# James L. Smoot, Ph.D., P.E.

## ENVIRONMENTAL ENGINEER AND HYDROLOGIST

June 23, 2000

Some of my specific concerns relative to the proposed development plan for Turnberry Square (based on plans prepared by Benchmark Associates and dated 6/1/00) are listed below. I did not have access to the engineer's supporting documents to review them for appropriateness of assumptions and methods and accuracy of calculations.

**Exhibit 2**  
**Cloverdale Lane looking north**

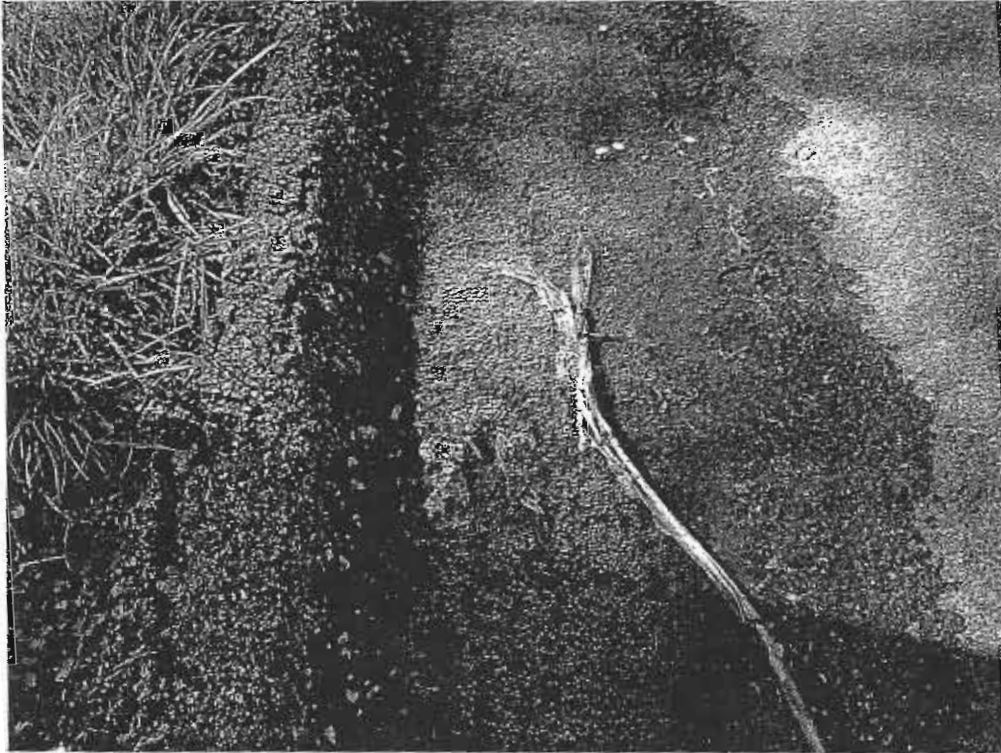
The existing drainage system in the subject watershed appears to have limited ability to effectively transport existing runoff waters to the natural receiving water bodies (Whites Creek / First Creek / Tennessee River). Based on reports by local residents and on photographs, numerous situations arise following storms of varying magnitudes where stormwaters back up on neighborhood roadways and adjacent properties. The natural drainageway has been impaired in several locations due to development encroachment and road construction. Some enhancements to the natural drainage system have been made in the upper end of the watershed (e.g., culverts along Tazewell Pike), but these enhancements were not continued along the remainder of the drainageway to provide adequate capacity for existing development. Any further development of property in the watershed which would result in increases in either runoff volume or runoff peak flows would likely have a negative impact on downstream properties. These negative impacts would likely consist of an increased frequency of nuisance and/or property-damaging flooding, reduction of aesthetic values associated with the drainageway, channel erosion, and sediment deposition. See Table 1 for a summary of estimates of runoff associated with different size storms and different dwelling unit densities on the Turnberry Square property. Note that the largest changes occur for the smaller but more frequent storms. Even if the stormwater management system for the Turnberry Square property is designed, constructed, and maintained to meet the minimum requirements of the Knoxville Ordinance for property in the Whites Creek basin (attenuation of peak flows up to the 100-year storm), many of the negative impacts listed above would still likely occur. Photographs depicting the current conditions of the receiving drainage area are shown in Exhibits 1 – 6.
